INNER WEST COUNCIL

DEVELOPMENT ASSESSMENT REPORT

Application No.	D/2019/134
Address	15 Edward Street, BALMAIN EAST NSW 2041
Proposal	Ground, first and second floor alterations and additions to heritage list dwelling-house and associated works.
Date of Lodgement	5 April 2019
Applicant	Lombardo Design Studio
Owner	Mr A L King and Mr D E Vanstone
Number of Submissions	1 submission
Value of works	\$514,497.00
Reason for determination at Planning Panel	<ul style="list-style-type: none"> Heritage Item Clause 4.6 variation to Floor Space Ratio exceeds 10%
Main Issues	<ul style="list-style-type: none"> Heritage Issues Stormwater Engineering Issues
Recommendation	Deferred Commencement Approval
Attachment A	Recommended conditions of consent
Attachment B	Plans of proposed development
Attachment C	Clause 4.6 Exception to Development Standards
Attachment D	Statement of Heritage Significance

051

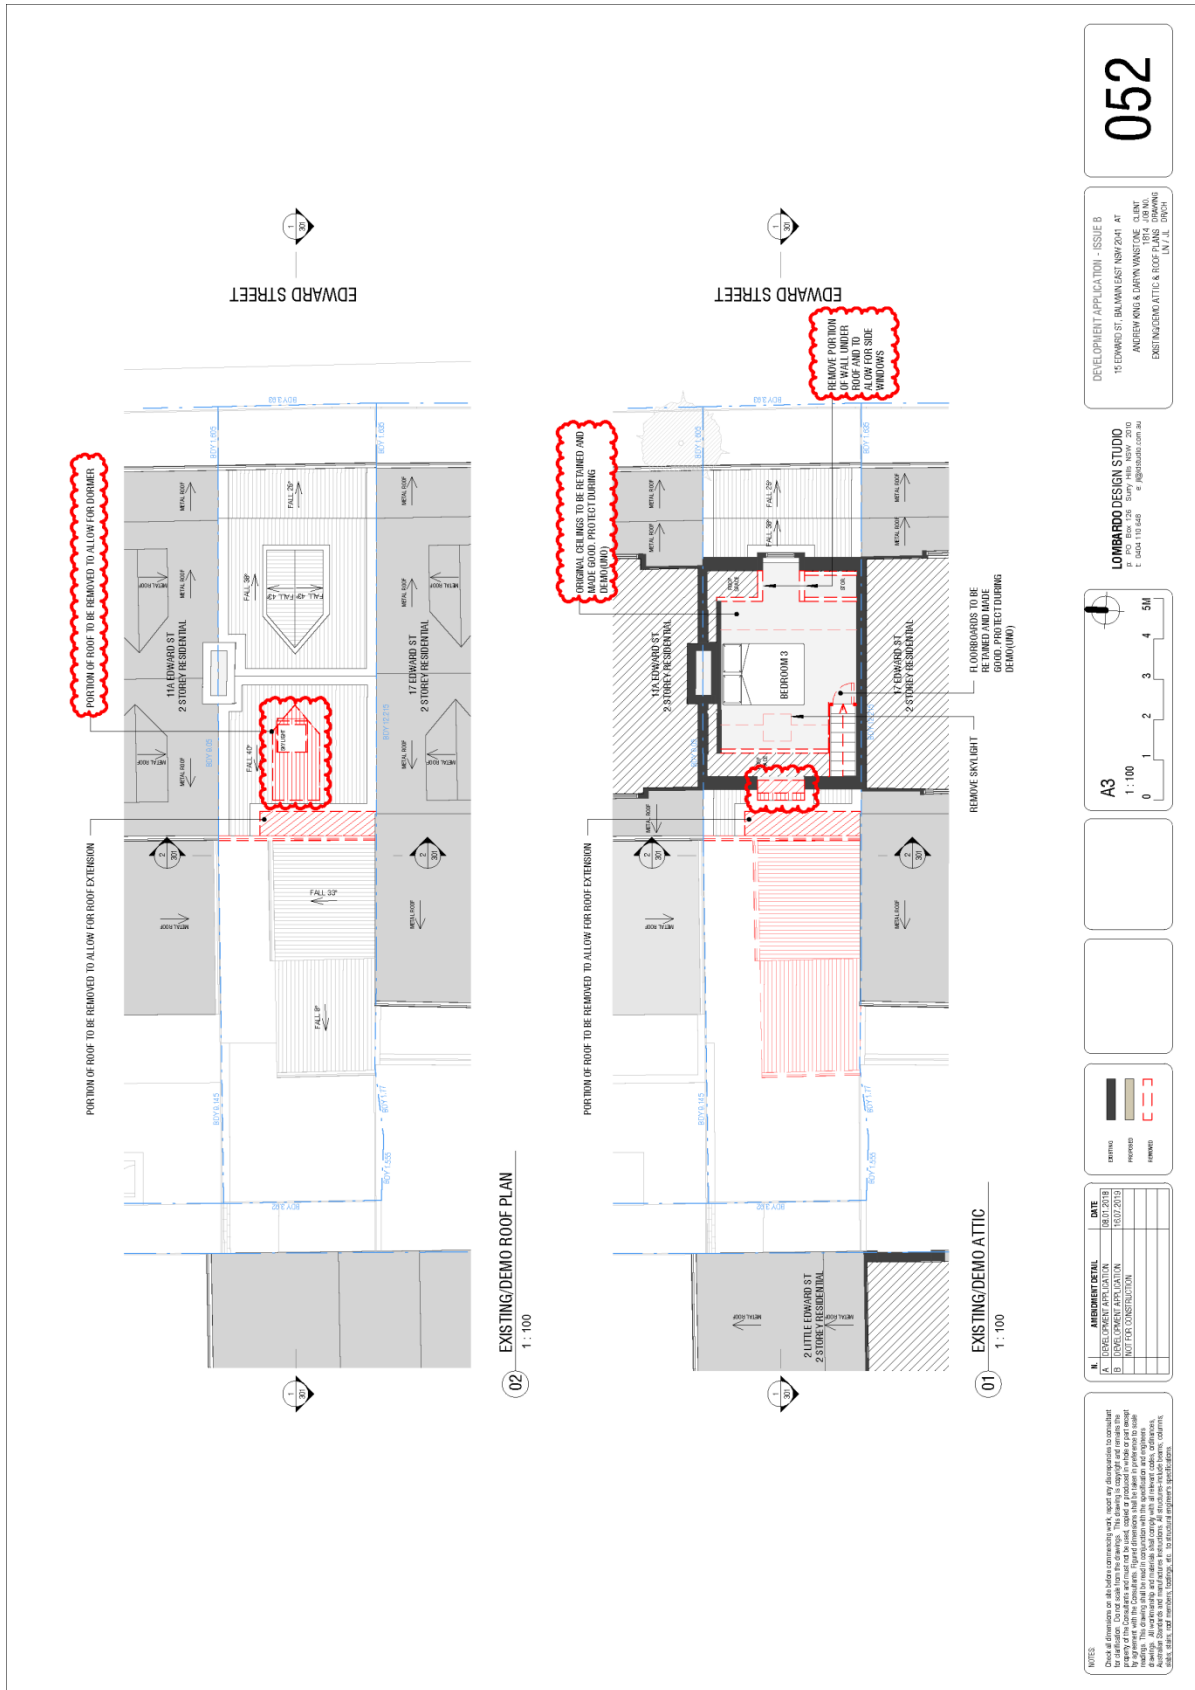
Comment: Amended plans submitted now retain the original stonework to the rear ground floor wing. However the updated plans seeks to demolish and convert the original window at the first floor level to a door entry linking the new first floor bedroom. As such, a design amendment condition is recommended as part of a Deferred Commencement consent. See Attachment A for further details.

- The layout of the new first floor bedroom over the kitchen is to be reworked so that the original window in the rear elevation is retained in its original location and conserved. A minimal opening is to be created to access the new bedroom. No additional windows or vents are to be added to the rear façade and the evidence of the ashlar line work is to be retained.
- No alterations are permitted to the front dormer and the side cheeks are to remain in their current configuration and be conserved.

1. Amended plans are to be submitted incorporating the following amendments:
 - a) The original window in the rear elevation on the first floor is to be retained in its original location and conserved.

052

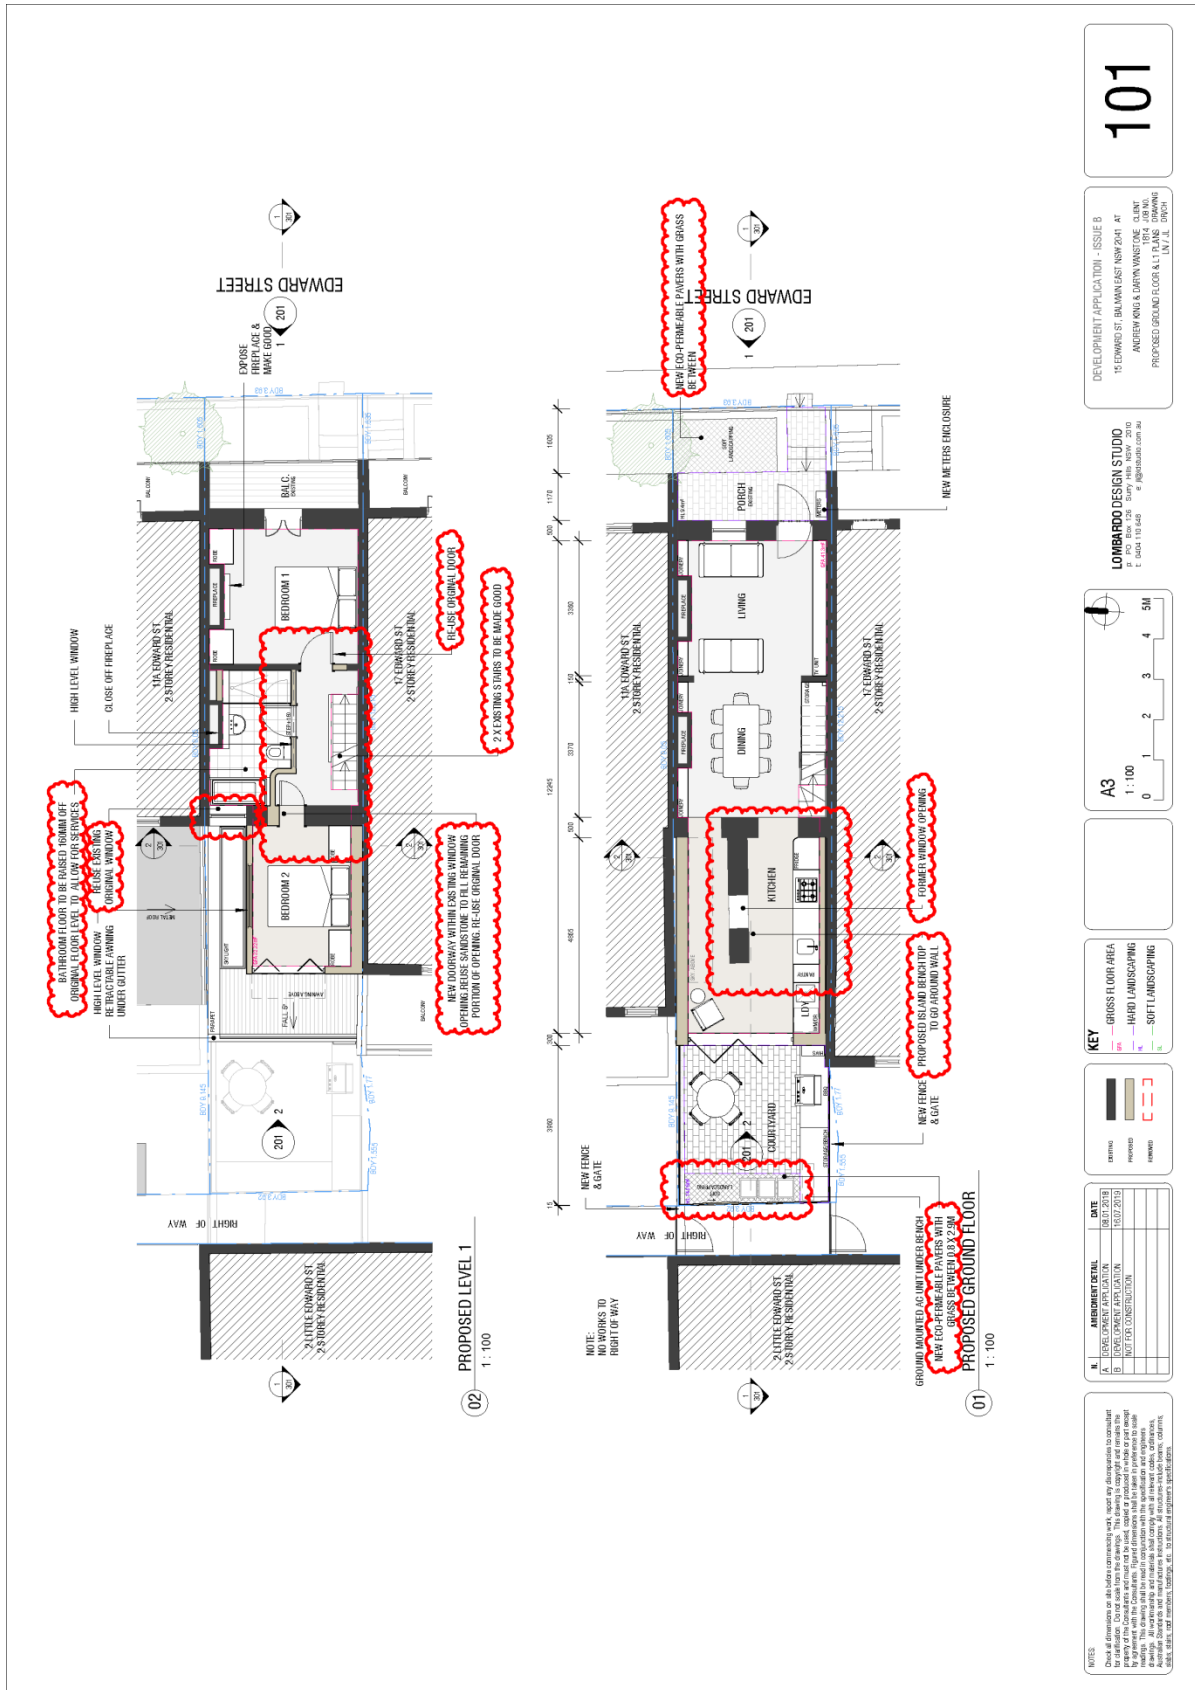
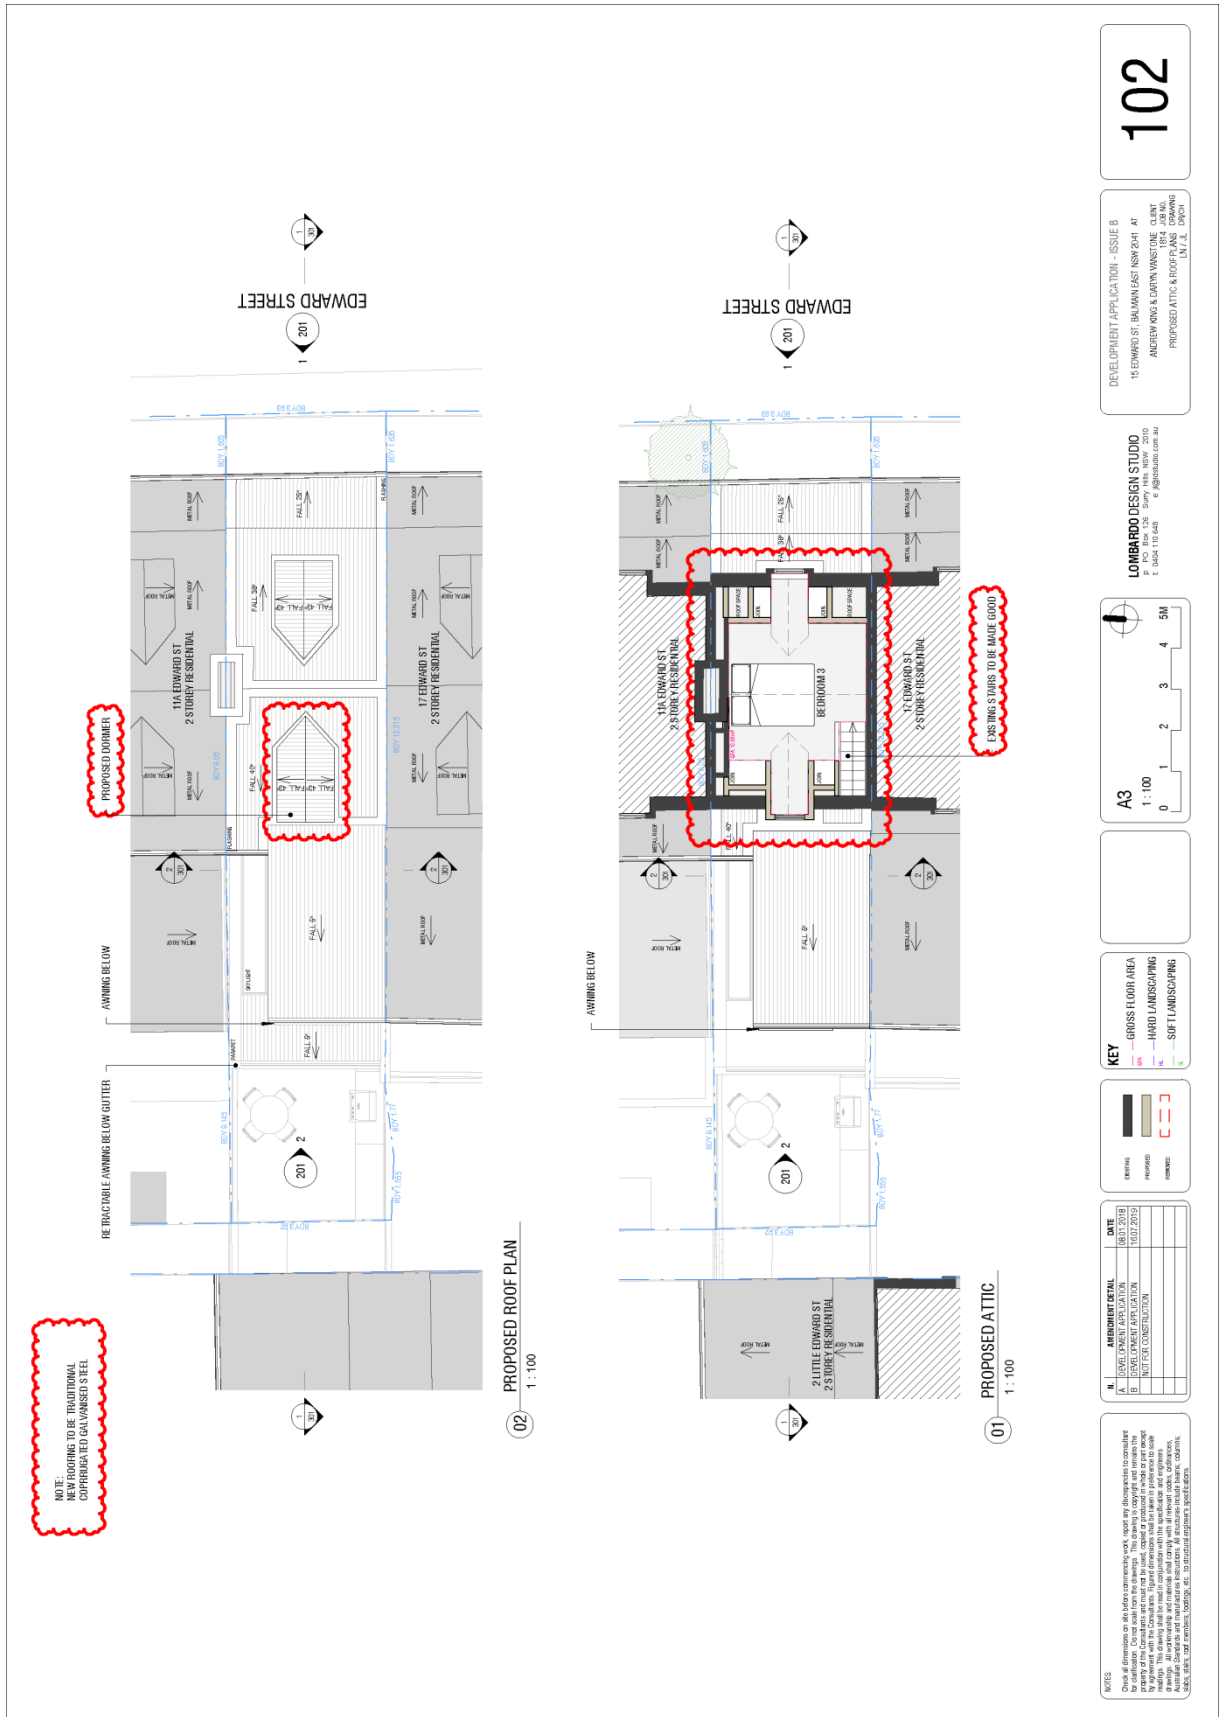
Comment: The amended plans have redesigned the rear skillion dormer window as per Council's request. However, it is noted that the proposed works to the existing front dormer window facing Edward Street are not supported on heritage grounds and are recommended to be conditioned accordingly on any consent granted. See Attachment A for further details.

Comment: The amended plans submitted to Council now depicts the proposed rear dormer window located on the second/attic floor level to match the existing dormers of No. 17, 11A & 7 Edward Street. As such, this element of the proposal is now acceptable, subject to conditions.
